**UNIFORM STANDARD DRAWINGS
CLARK COUNTY AREA**

VOLUME II - YEAR 2007 REVISIONS

UNIFORM STANDARD DRAWINGS CLARK COUNTY AREA		
SCHOOL FLASHING SIGN ON POLE WITH LUMINAIRE		
DATE 9-14-08	DWG. NO. 404.400	SHEET 1 OF 2

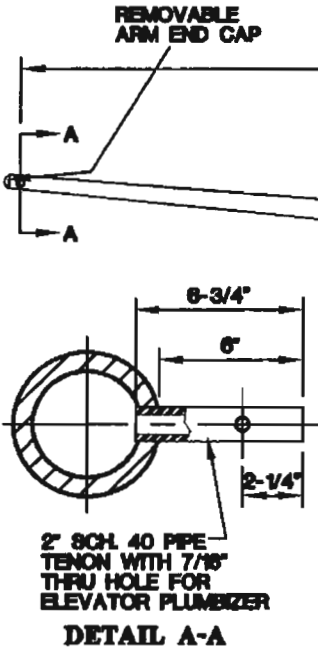
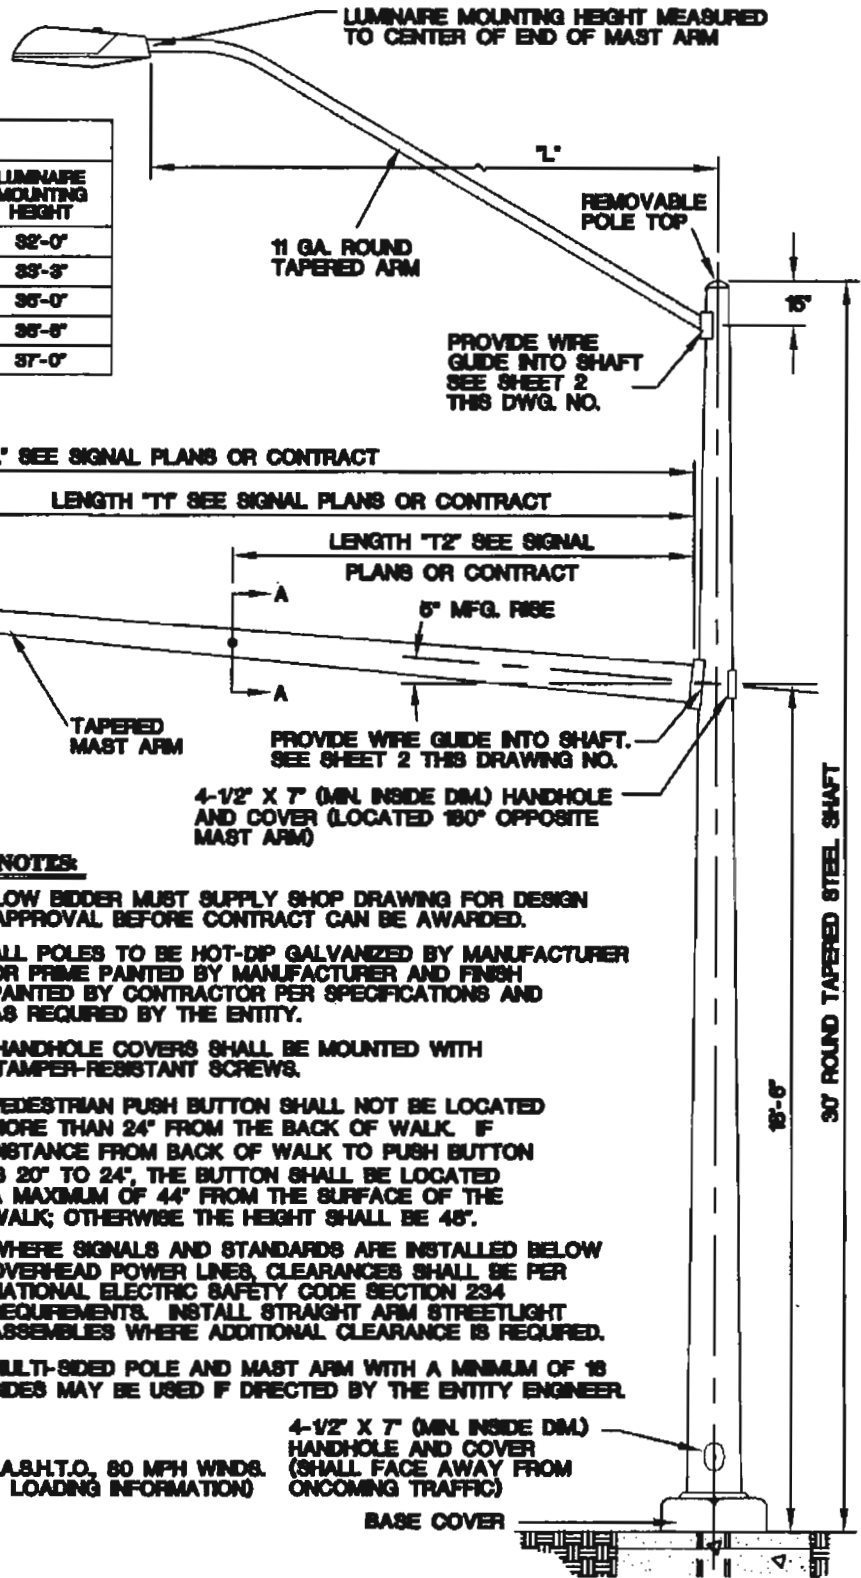
Drawing Number	Title	Nature of Change	Effective Date
404.400	"School Flashing Sign On Pole With Luminaire"	Revision to allow the use of multi-sided traffic signal poles.	01/01/07

6. MULTI-SIDED POLE AND MAST ARM WITH A MINIMUM OF 16 SIDES MAY BE USED IF DIRECTED BY THE ENTITY ENGINEER.

**TYPE XX-30'-0"
SIGNAL & LUMINAIRE POLE
(45' OR LESS MAST ARMS)**

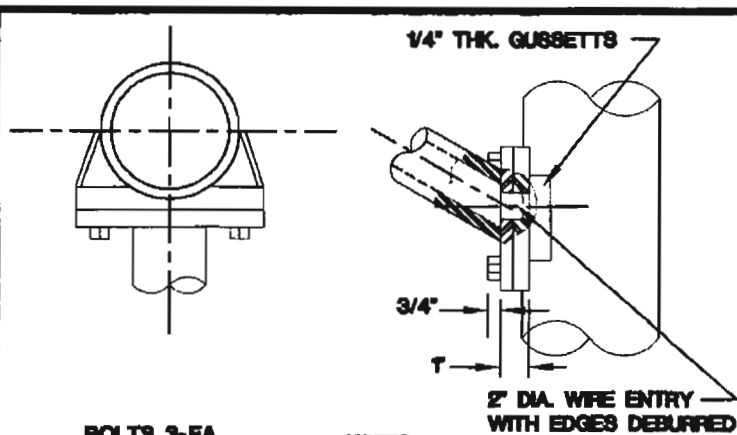
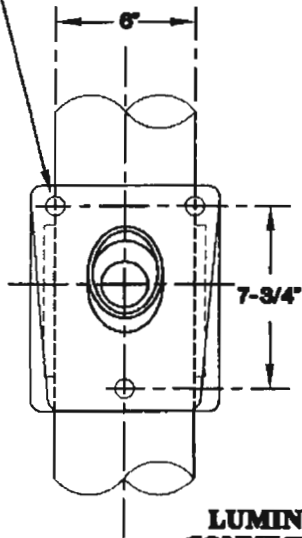
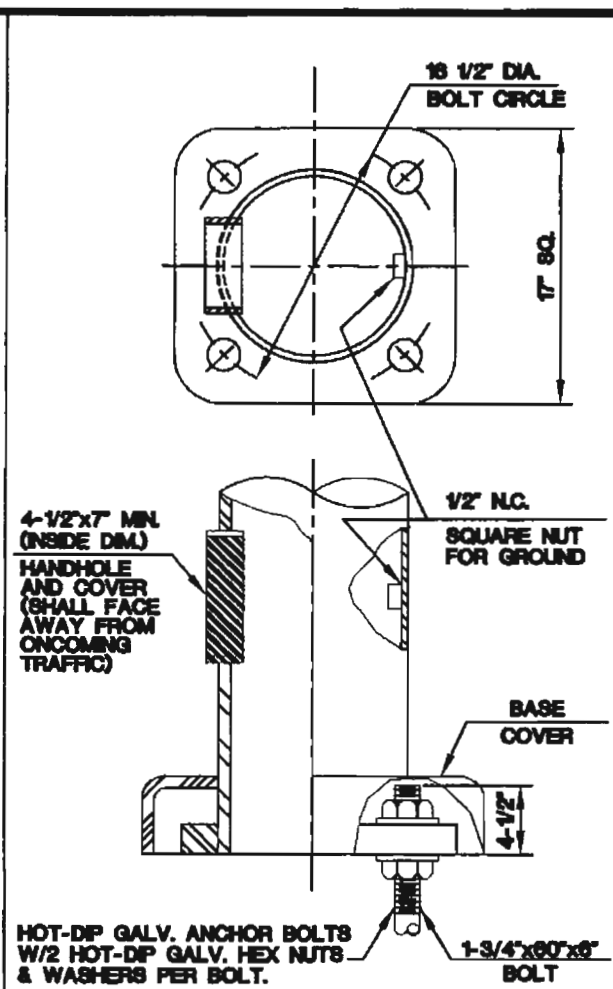
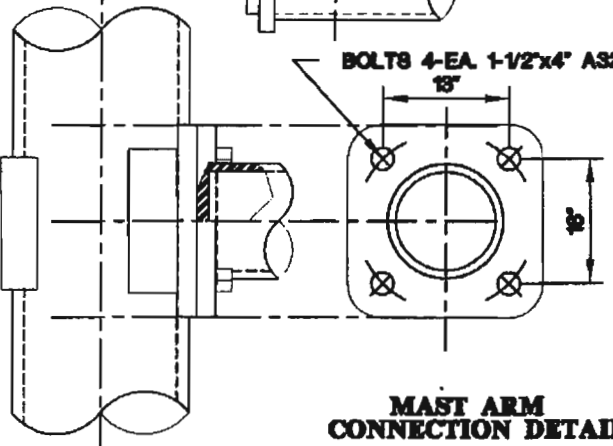
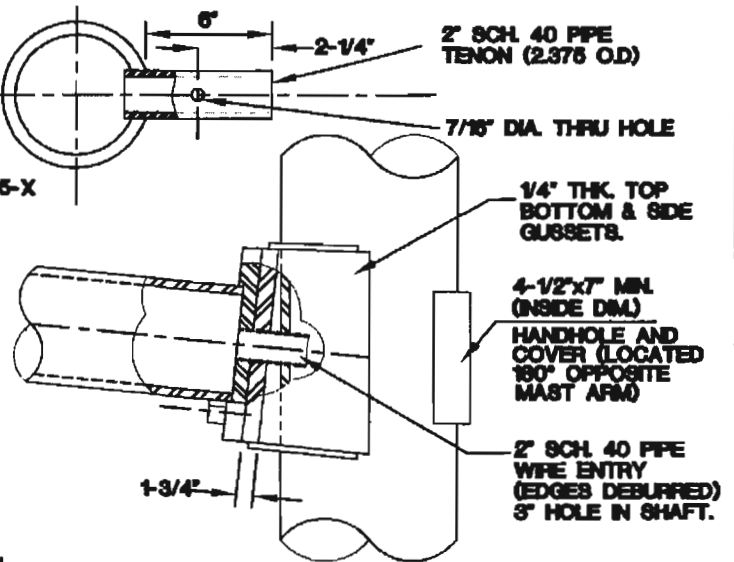
404.406	"Type XX-30'-0" Signal & Luminaire Pole (Sheets 1-4 of 6)"	Revision to allow the use of multi-sided traffic signal poles.	01/01/07
404.406C	"Red Light Running Indicator Installation Details" - Addition of drawing to improve traffic safety and law enforcement.	Addition to improve traffic safety and law enforcement.	01/01/07

1. LOW BIDDER MUST SUPPLY SHOP DRAWING FOR DESIGN APPROVAL BEFORE CONTRACT CAN BE AWARDED.
2. ALL POLES TO BE HOT-DIP GALVANIZED BY MANUFACTURER OR PRIME PAINTED BY CONTRACTOR PER SPECIFICATIONS AND AS REQUIRED BY THE ENTITY.
3. HANDHOLE COVERS SHALL BE MOUNTED WITH TAMPER-RESISTANT SCREWS.
4. PEDESTRIAN PUSH BUTTON SHALL NOT BE LOCATED MORE THAN 24" FROM THE BACK OF WALK. IF DISTANCE FROM BACK OF WALK TO PUSH BUTTON IS 20" TO 24", THE BUTTON SHALL BE LOCATED A MAXIMUM OF 44" FROM THE SURFACE OF THE WALK; OTHERWISE THE HEIGHT SHALL BE 48".
5. WHERE SIGNALS AND STANDARDS ARE INSTALLED BELOW OVERHEAD POWER LINES, CLEARANCES SHALL BE PER NATIONAL ELECTRIC SAFETY CODE SECTION 254 REQUIREMENTS. INSTALL STRAIGHT ARM STREETLIGHT ASSEMBLIES WHERE ADDITIONAL CLEARANCE IS REQUIRED.
6. MULTI-SIDED POLE AND MAST ARM WITH A MINIMUM OF 10 SIDES MAY BE USED IF DIRECTED BY THE ENTITY ENGINEER.

SPECIFICATION REFERENCE	UNIFORM STANDARD DRAWINGS CLARK COUNTY AREA		
	TYPE XX 20'-0" SIGNAL POLE (45' OR LESS MAST ARMS)		
	DATE 9-14-08	DWG. NO. 404.407	SHEET 1 OF 2

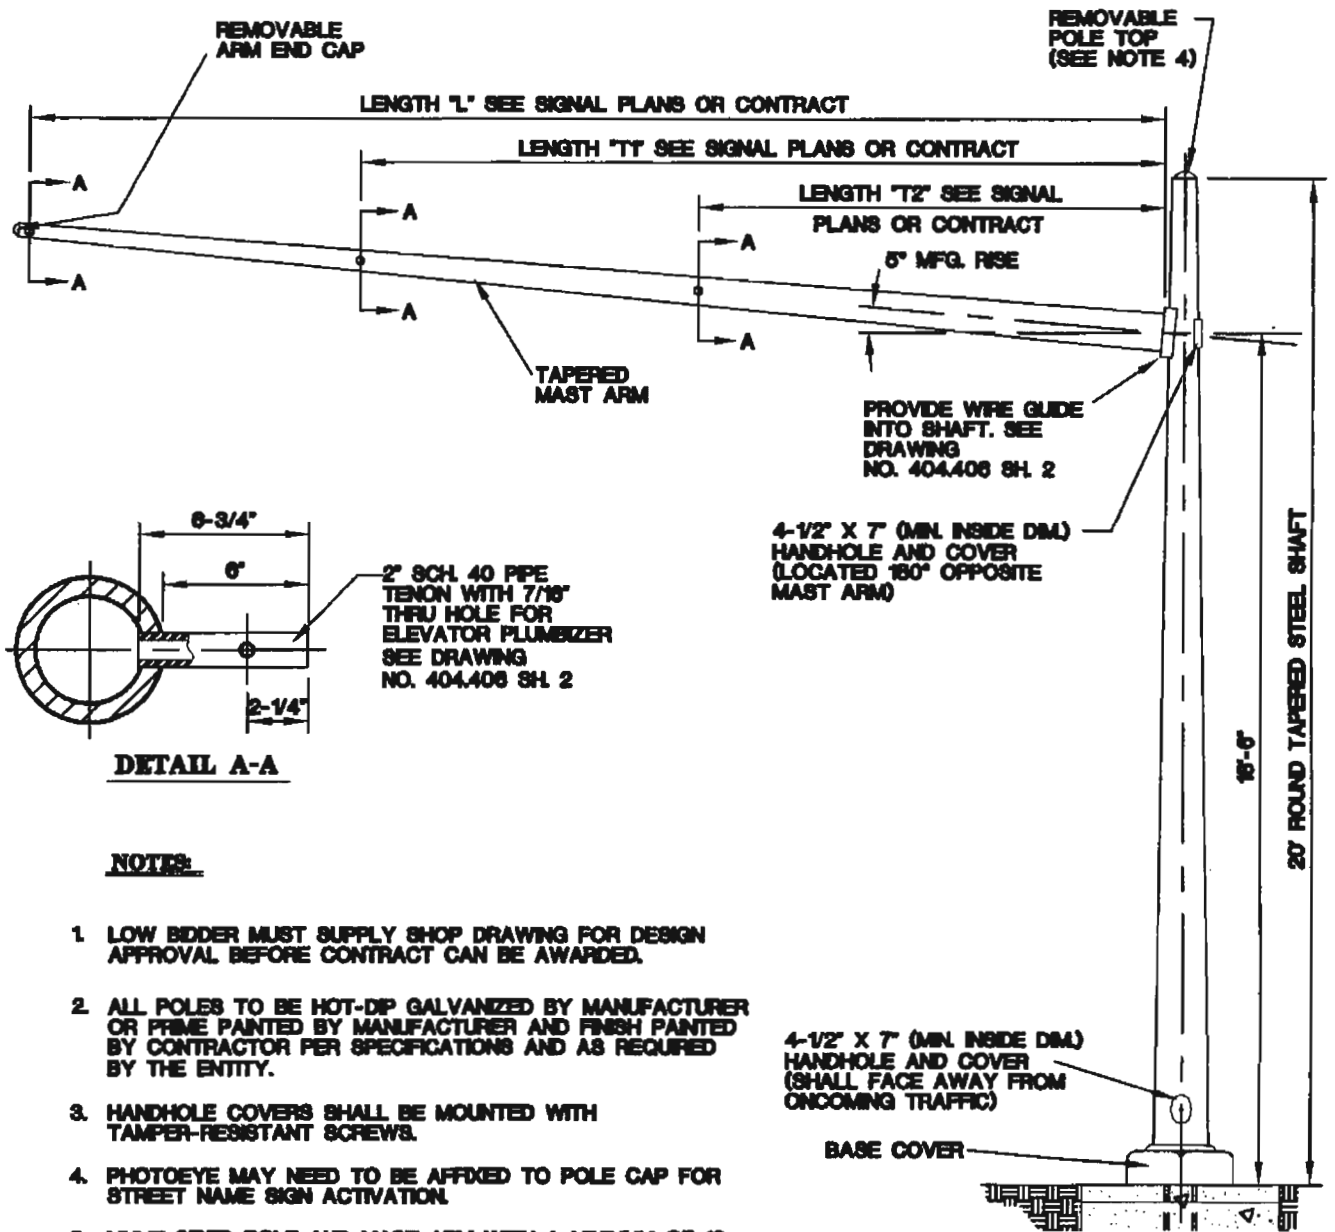
404.407	"Type XX-A-20' - 0" Signal Pole"	Revision to allow the use of multi-sided traffic signal poles.	01/01/07
404.410	"30' Pole With School Flashing Sign"	Revision to allow the use of multi-sided traffic signal poles.	01/01/07

1. LOW BIDDER MUST SUPPLY SHOP DRAWING FOR DESIGN APPROVAL BEFORE CONTRACT CAN BE AWARDED.
2. ALL POLES TO BE HOT-DIP GALVANIZED BY MANUFACTURER OR PRIME PAINTED BY MANUFACTURER AND FINISH PAINTED BY CONTRACTOR PER SPECIFICATIONS AND AS REQUIRED BY THE ENTITY.
3. HANDHOLE COVERS SHALL BE MOUNTED WITH TAMPER-RESISTANT SCREWS.
4. PHOTOEYE MAY NEED TO BE AFFIXED TO POLE CAP FOR STREET NAME SIGN ACTIVATION.
5. MULTI-SIDED POLE AND MAST ARM WITH A MINIMUM OF 18 SIDES MAY BE USED IF DIRECTED BY THE ENTITY ENGINEER.

CLARK COUNTY AREA	
SCHOOL SIGN POLE TYPE XX-A	
DATE 04-12-07	DWG. NO. 404.412

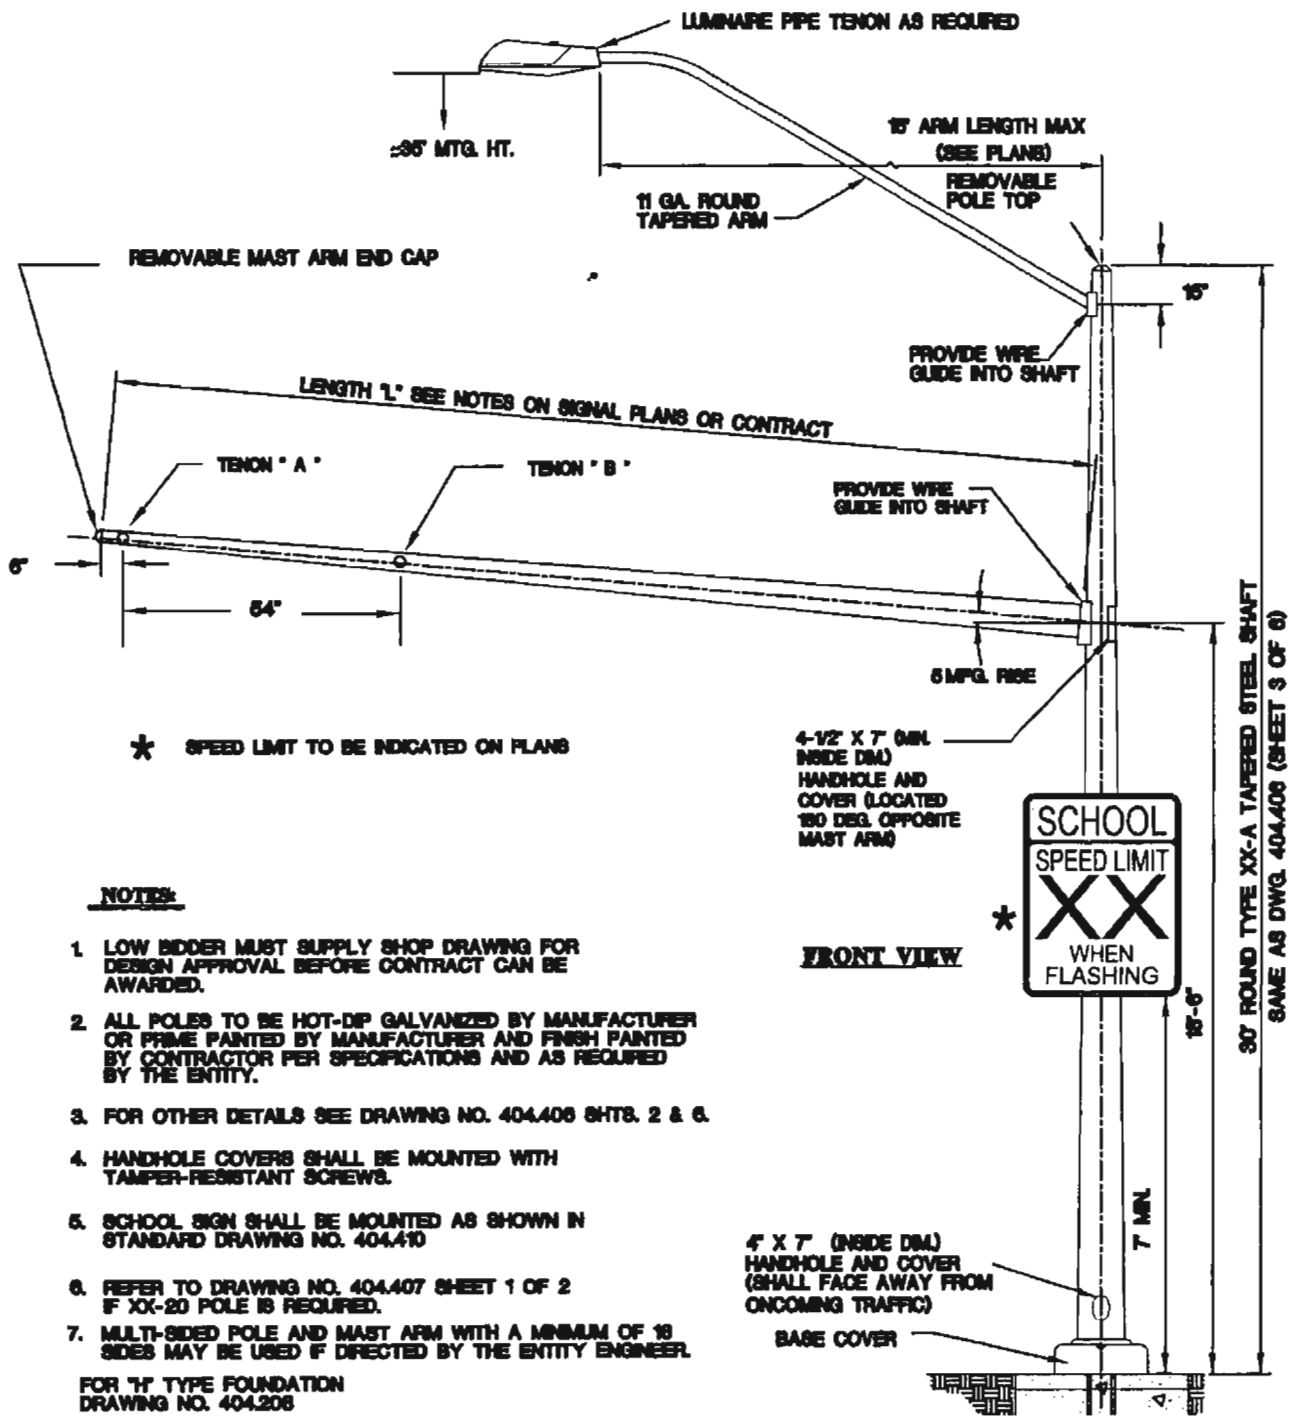
404.411	"School Sign Mounted On Traffic Signal Standard"	Deleted	07/01/07
404.412	"School Sign Pole Type XX - A' "	Revision to allow the use of multi-sided traffic signal poles.	01/01/07

404.412	"School Sign Pole Type XX - A' "	Revised to modify the mast arm with a five (5) degree rise and allow the use of multi-sided poles for traffic signal installations.	07/01/07

SPECIFICATION REFERENCE	UNIFORM STANDARD DRAWINGS CLARK COUNTY AREA	
	UTILITY CABLE CLEARANCE OVER TRAFFIC SIGNALS NEW INSTALLATION ONLY	
	DATE 2-08-07	DWG. NO. 404.418A

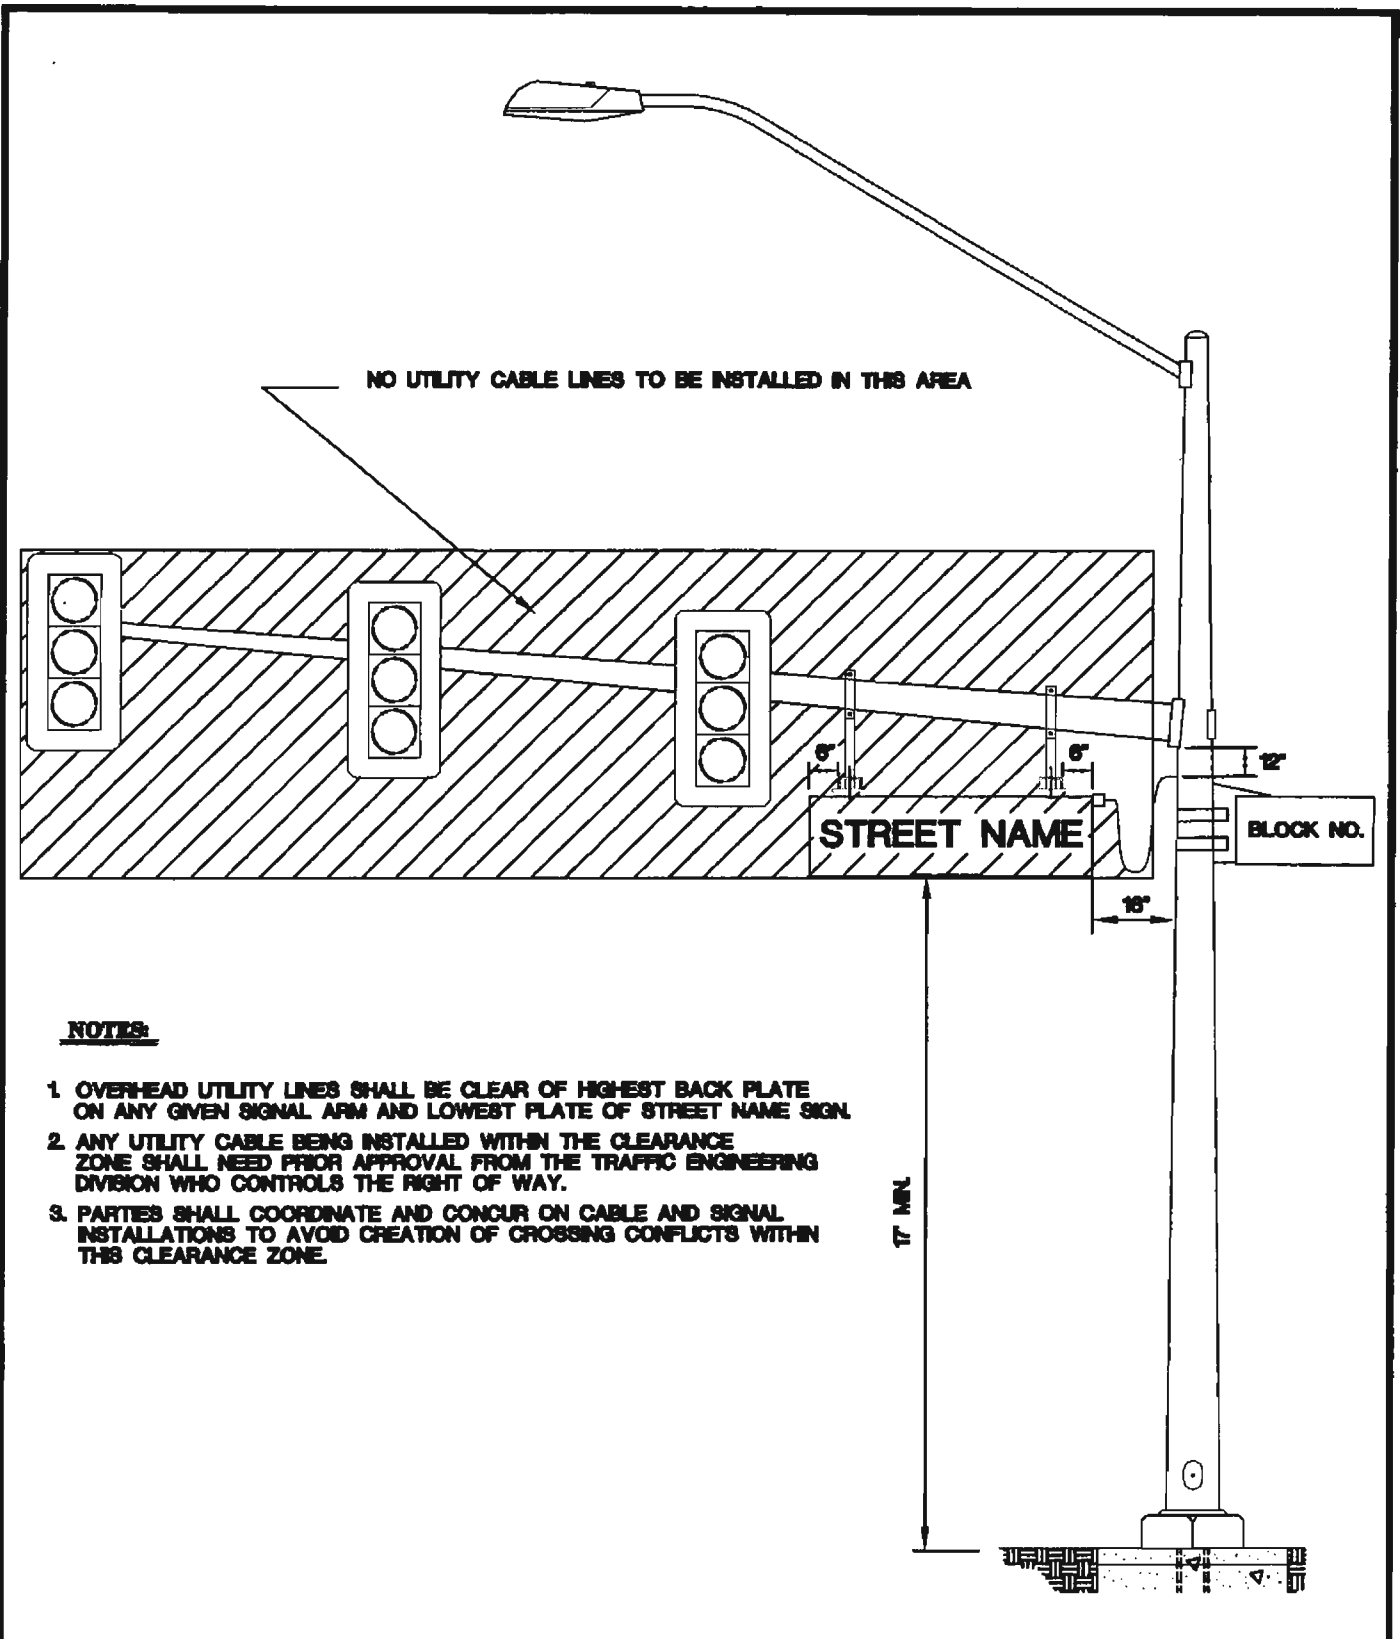
404.413	"School Sign Pole Type XX-20' "	Deleted	07/01/07
404.416A	"Utility Cable Clearance Over Traffic Signals New Installation Only"	Addition to depict a clearance zone for traffic signals from overhead utility lines.	07/01/07

1. OVERHEAD UTILITY LINES SHALL BE CLEAR OF HIGHEST BACK PLATE ON ANY GIVEN SIGNAL ARM AND LOWEST PLATE OF STREET NAME SIGN.
2. ANY UTILITY CABLE BEING INSTALLED WITHIN THE CLEARANCE ZONE SHALL NEED PRIOR APPROVAL FROM THE TRAFFIC ENGINEERING DIVISION WHO CONTROLS THE RIGHT OF WAY.
3. PARTIES SHALL COORDINATE AND CONCUR ON CABLE AND SIGNAL INSTALLATIONS TO AVOID CREATION OF CROSSING CONFLICTS WITHIN THIS CLEARANCE ZONE.
